Pines Dining Hall + Servery Addition

Northern Health Authority

Addendum No. 2

DGBK Project No. 17-110

E101

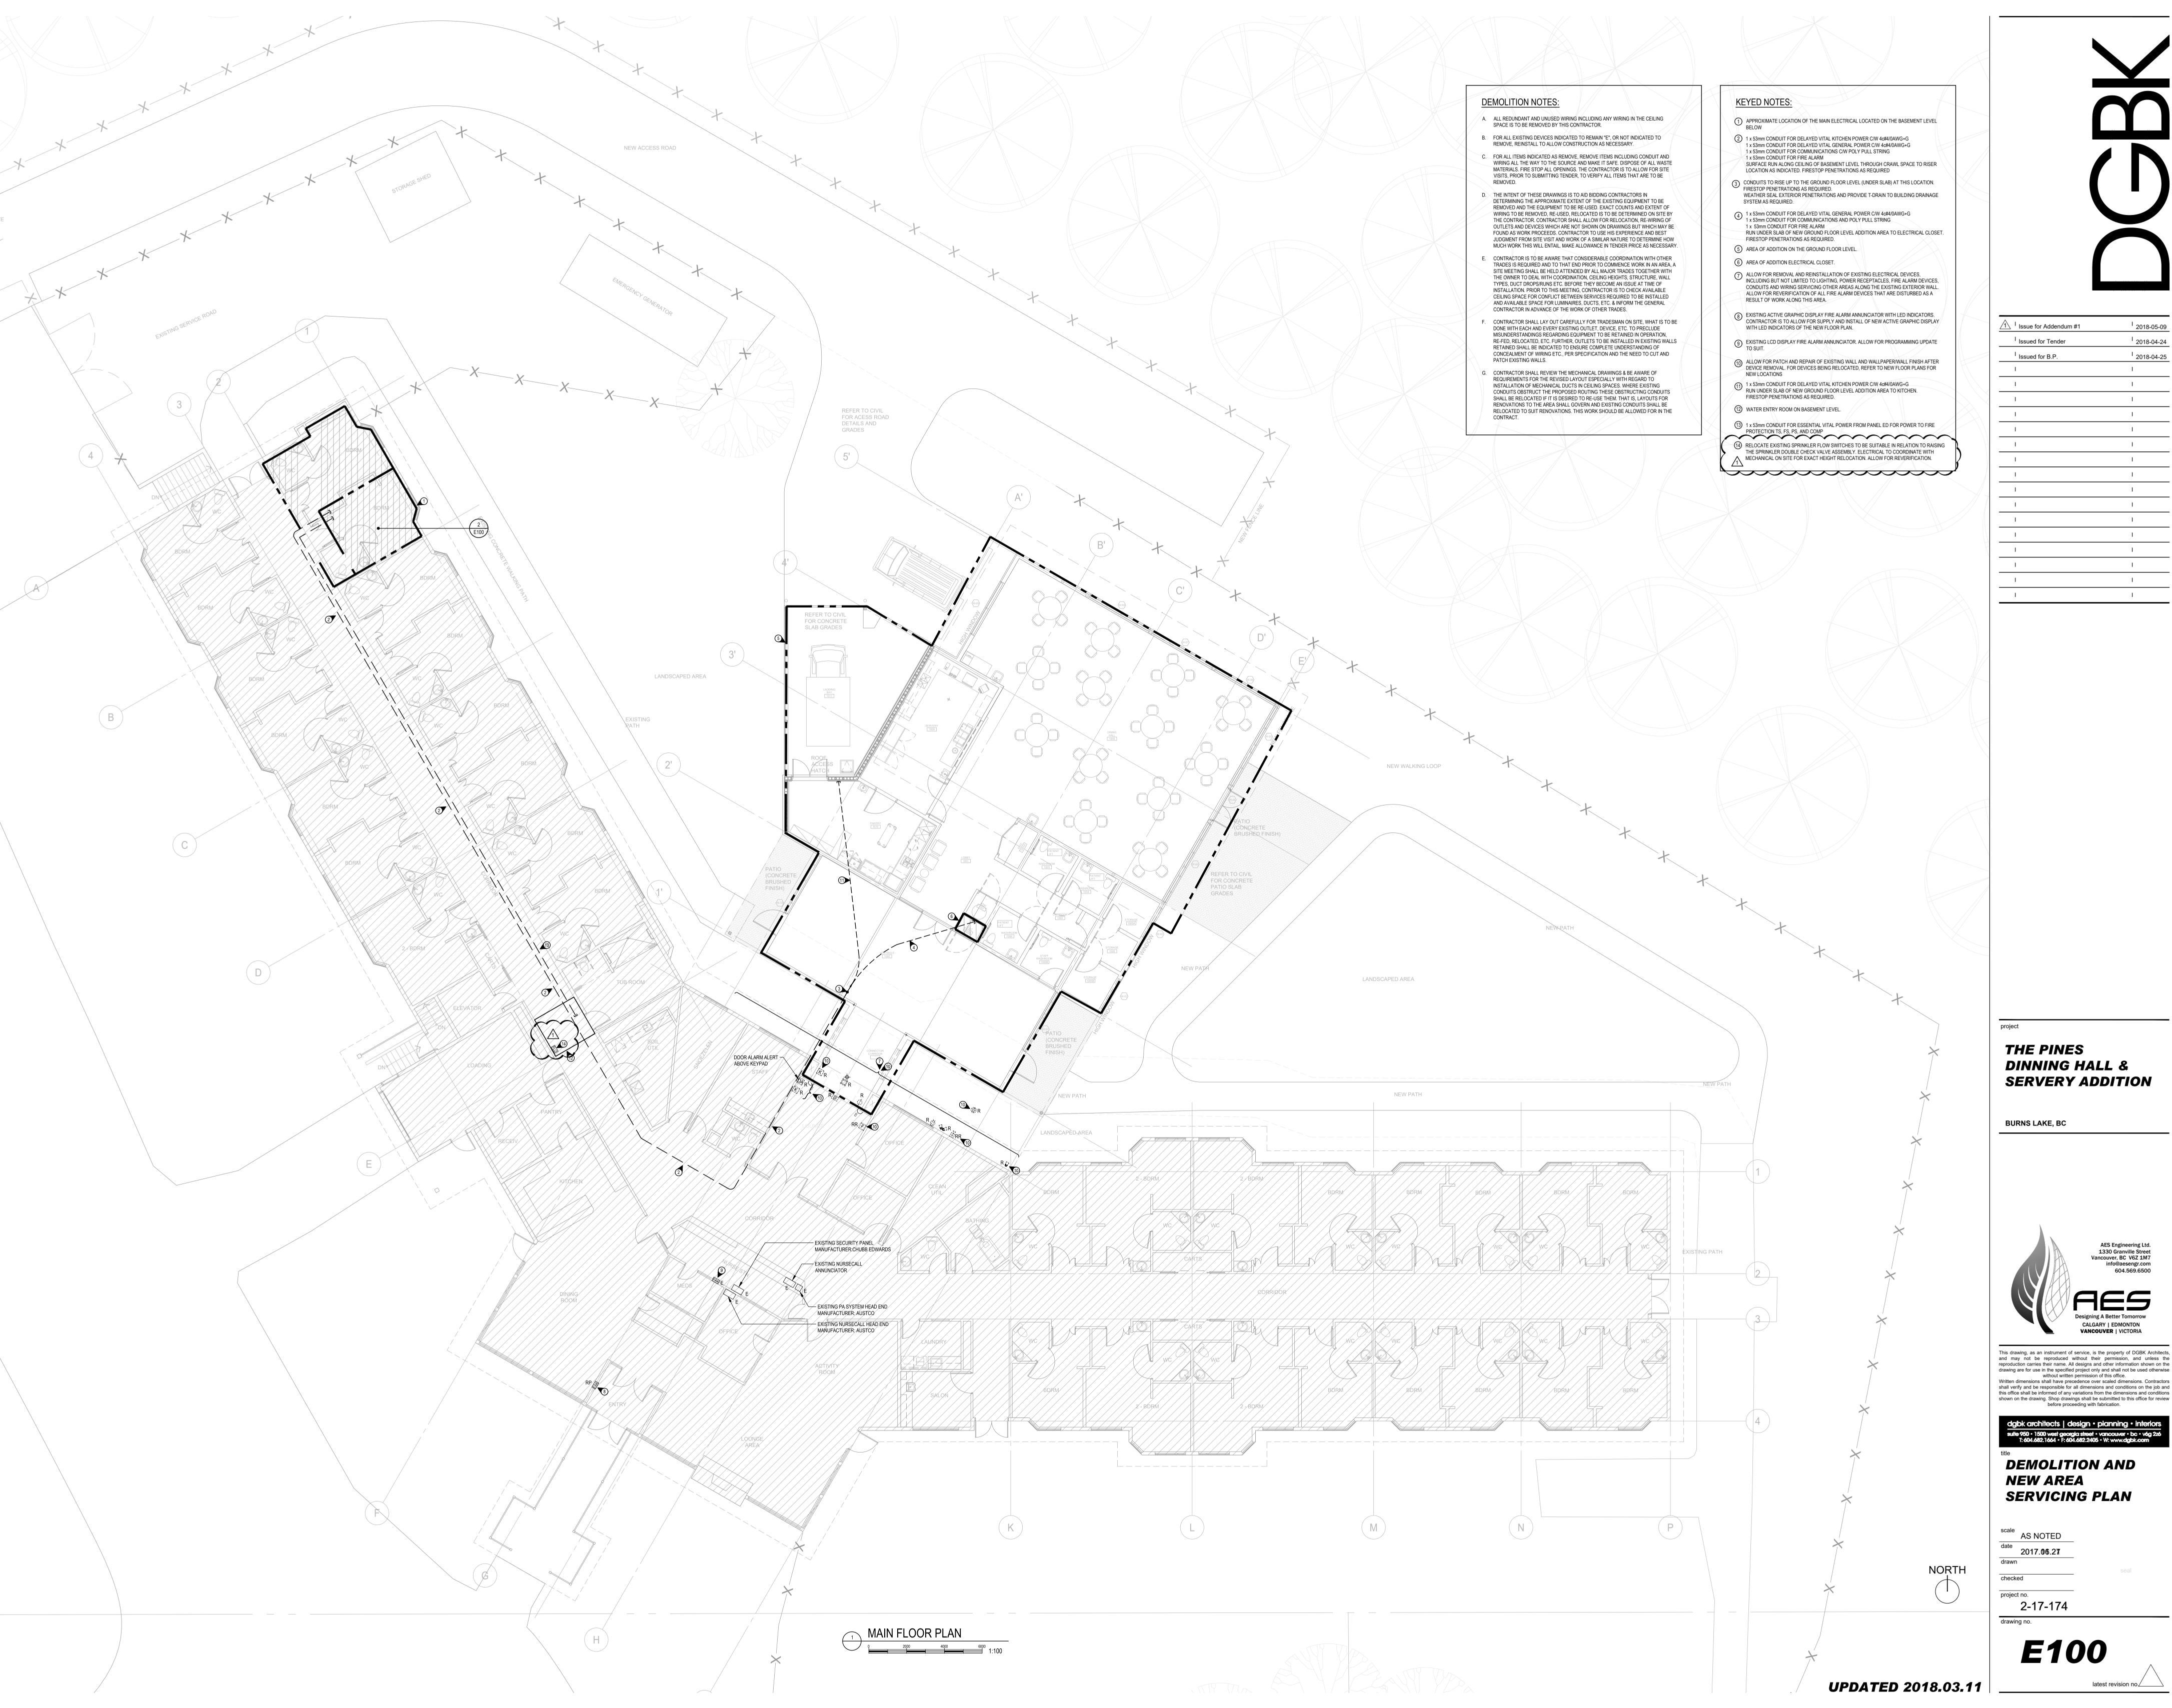
- .1 Two additional baseboard heaters have been added.
- .2 All baseboard heaters have been split into two 750W units instead of 1500W single units.
- .3 2 additional electrical forced flow heaters have been added.

DEMOLITION AND SERVICING PLAN

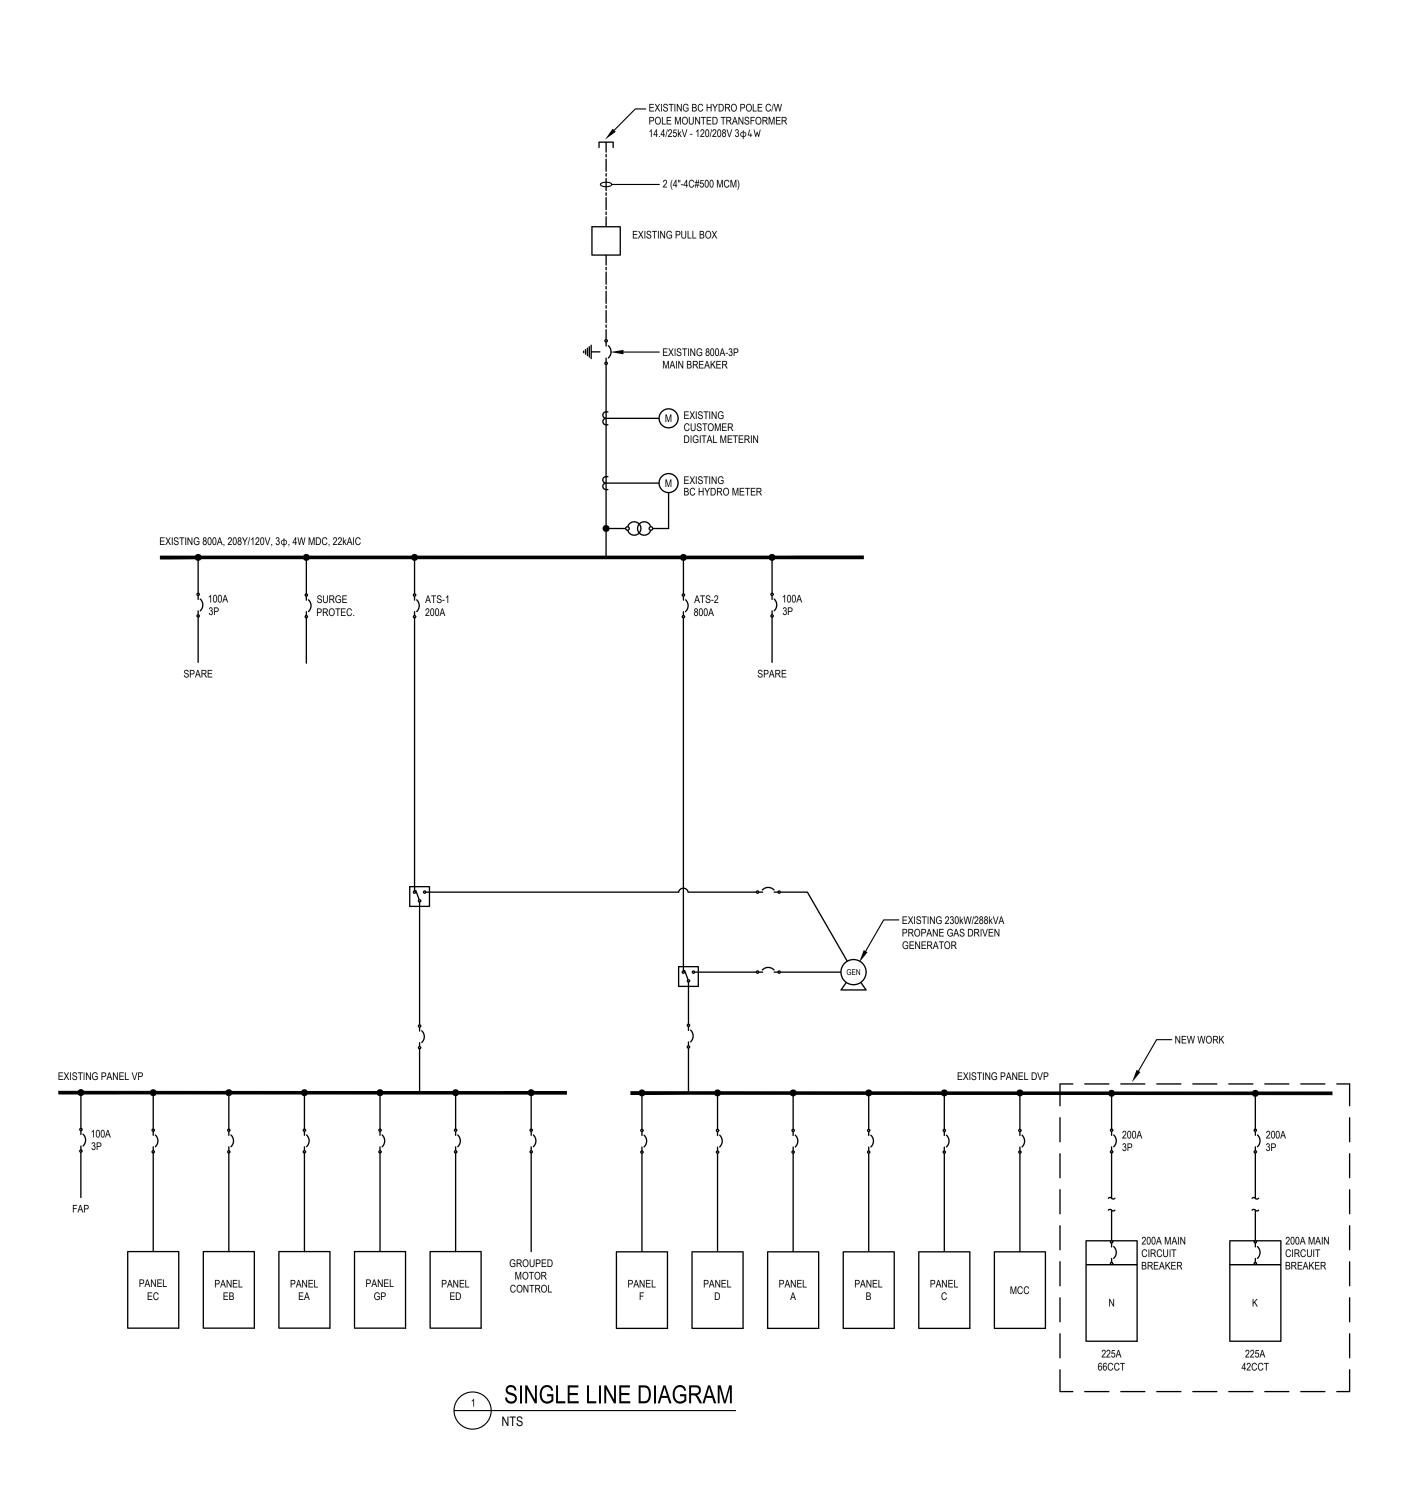
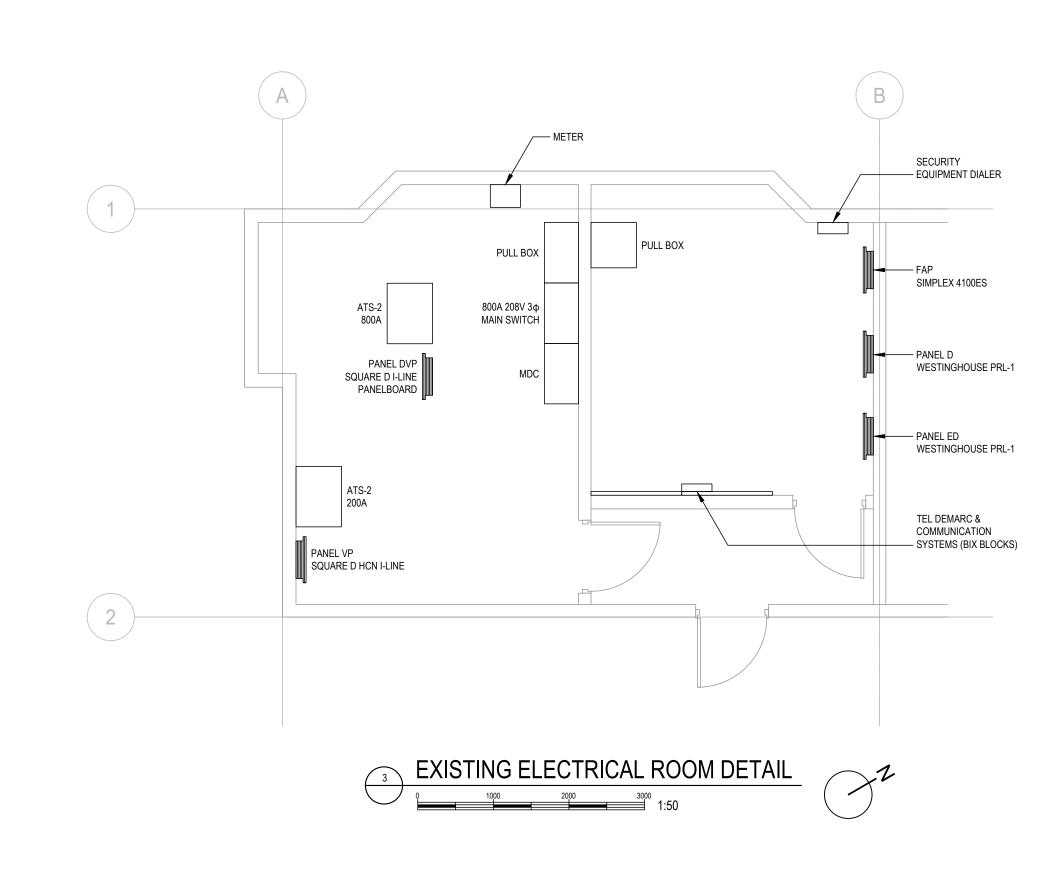
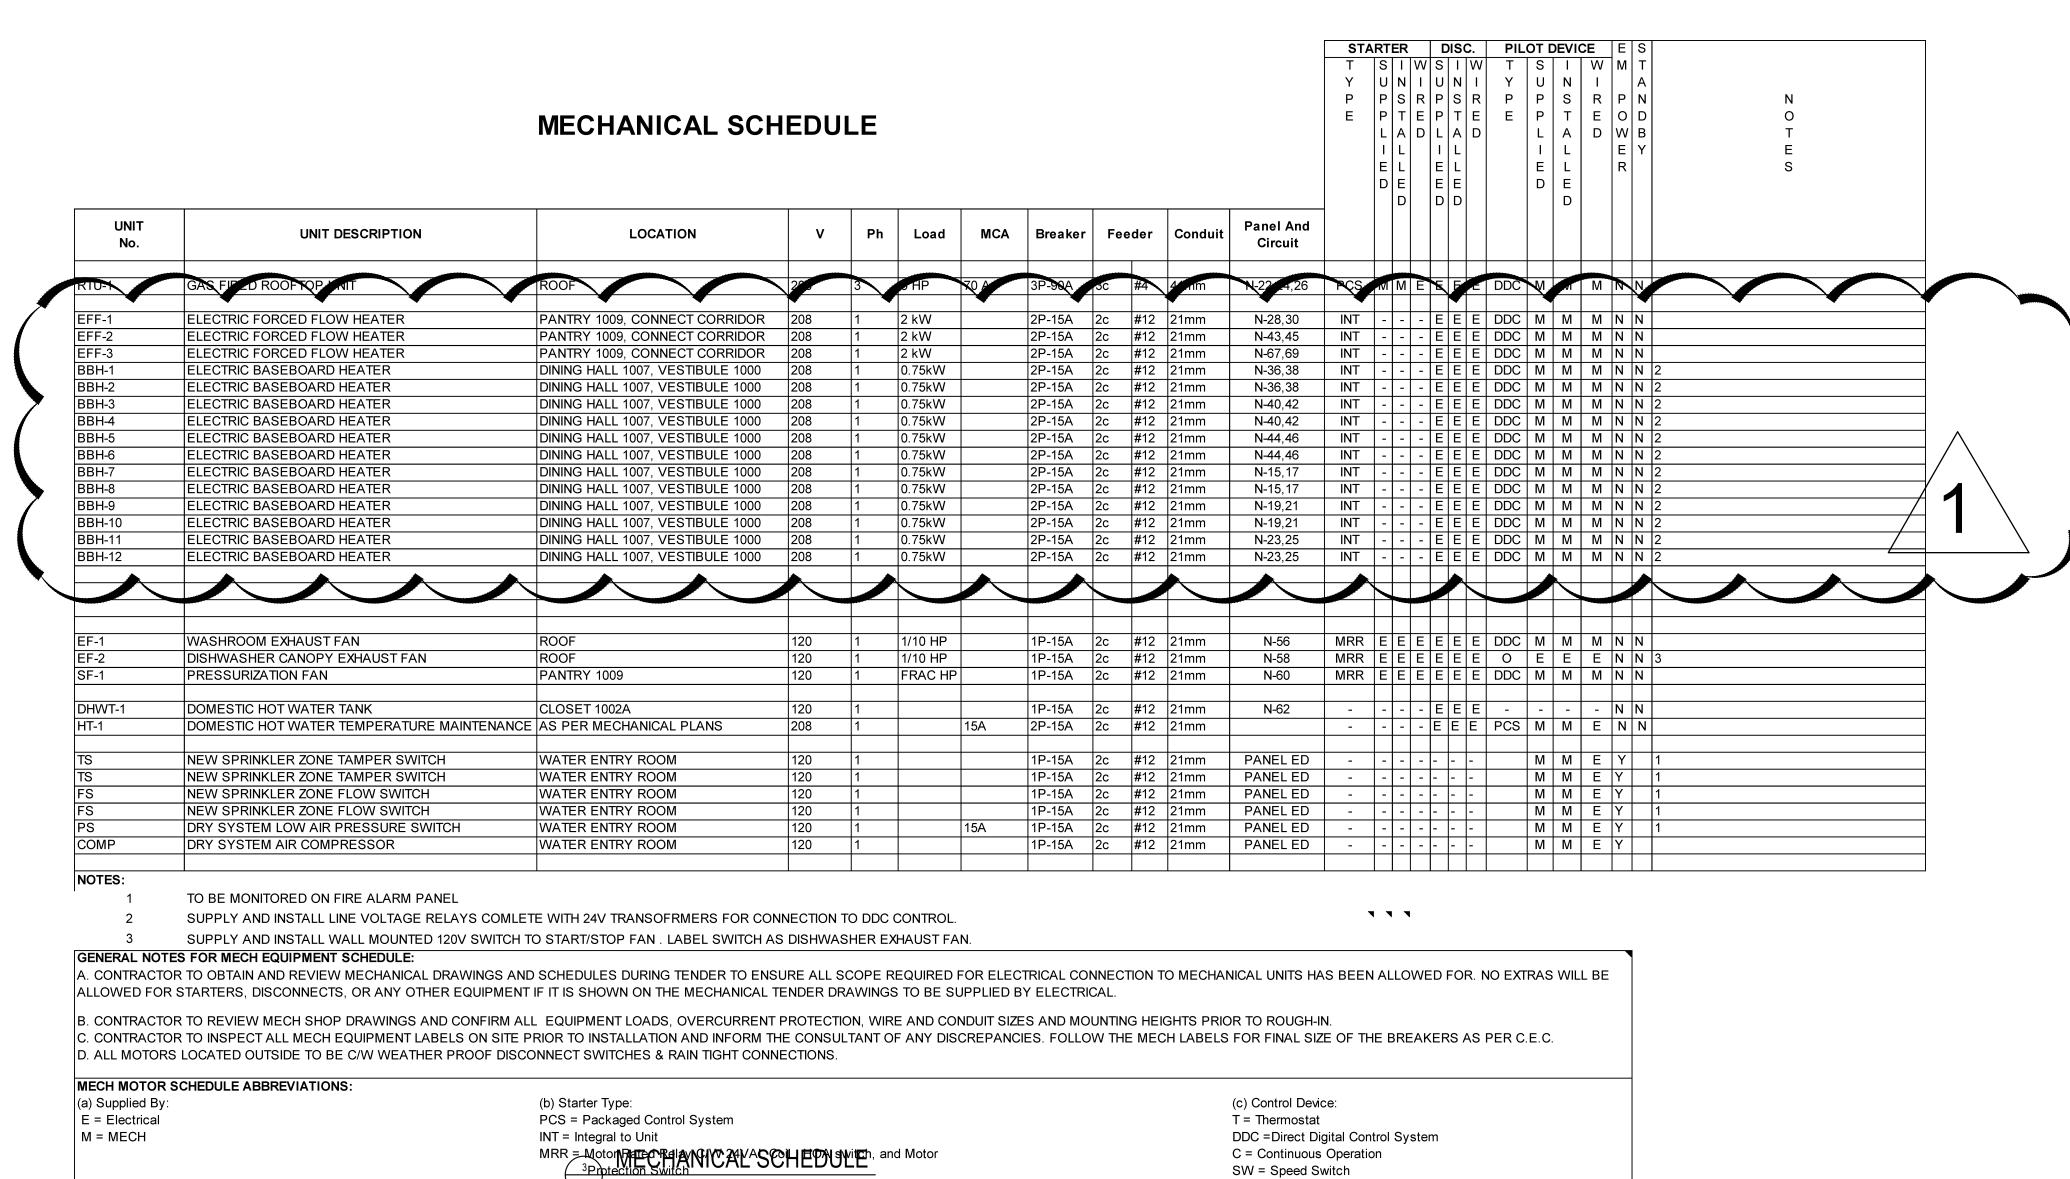
.1 A note has been added regarding the relocation and reverification of seven existing sprinkler flow switches. Switches need to be raised accordingly to the raising of the existing sprinkler double check valve assembly.
